McCULLOCH CORPORATION
SERVICE BULLETIN

1556

MODEL: PM 55, PM 60, SP 60, MAC 10-10, 7-10A, SP-81

SUBJECT: Crankcase, Oil Pulse Pump, Gasket

Figure 1. (Note: Saw is upside down, with oil tank cover off.) Pencil pointing to oil pump positioning boss.

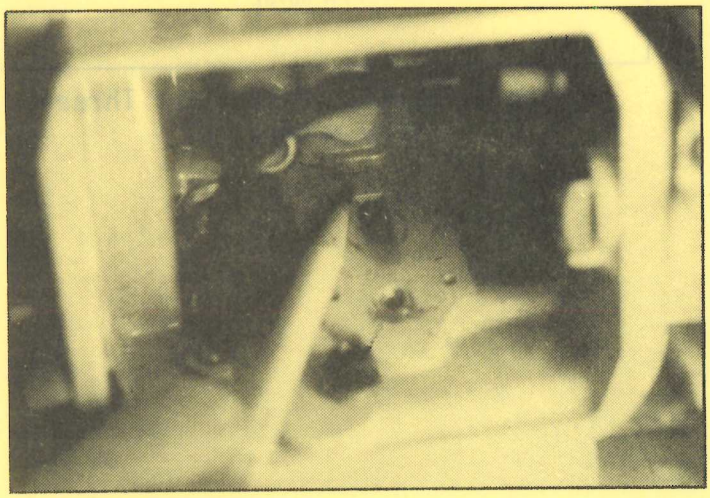
Late models, in production, of these saws are equipped with cast-in locating boss at the top of the oiler tank (crankcase) (Fig. 1).

Figure 2. Automatic Chain Oil Pumps compared.

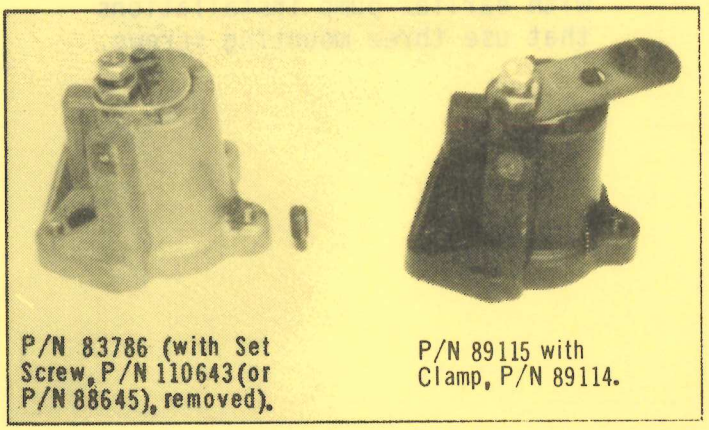
The oil pulse pump is now made of wear-resistant plastic and is interchangeable with the metal pump (Fig. 2). The plastic pump requires a clamp for better mounting stability. Any pump mounted in a crankcase with the locating boss must have the Set Screw (P/N 110643 or 88645), removed.

On all models equipped with Pulse Pump Assembly, P/N 89115, the pump is mounted in the oiler tank with a single screw, (P/N 110713). Washer, P/N 24236, used with this screw has been replaced by P/N 100003, which is wider, distributes the load more, and better protects the pump body.

With the change to Pump Assembly, P/N 89115, which has a more wear resistant plastic body, Washer, P/N 60937, (teflon) used on the pump piston, has been discontinued.

P/N 83786 (with Set Screw, P/N 110643 (or P/N 88645), removed).

P/N 89115 with Clamp, P/N 89114.

Figure 3. (OLD) and (NEW) Gaskets compared.

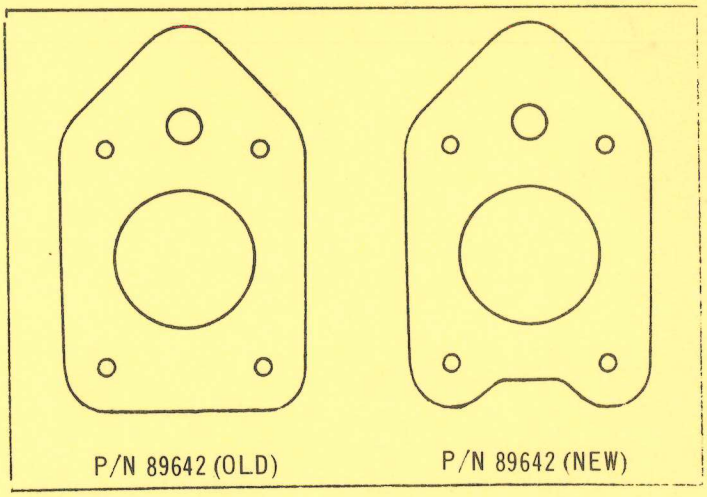
The new Gasket, P/N 89642 (NEW), has a notch for the positioning boss, and replaces the old Gasket, P/N 89642 (OLD), which has no notch (Fig. 3).

The (NEW) gasket is further distinguished by adhesive backing on one side that is covered by protective paper (which is to be removed before installation).

Both gaskets carry the same part number because Gasket, P/N 89642 (NEW), will backfit

for pump installations with one mounting screw and one set screw; however, Gasket, P/N 89642 (OLD), will not forward fit.
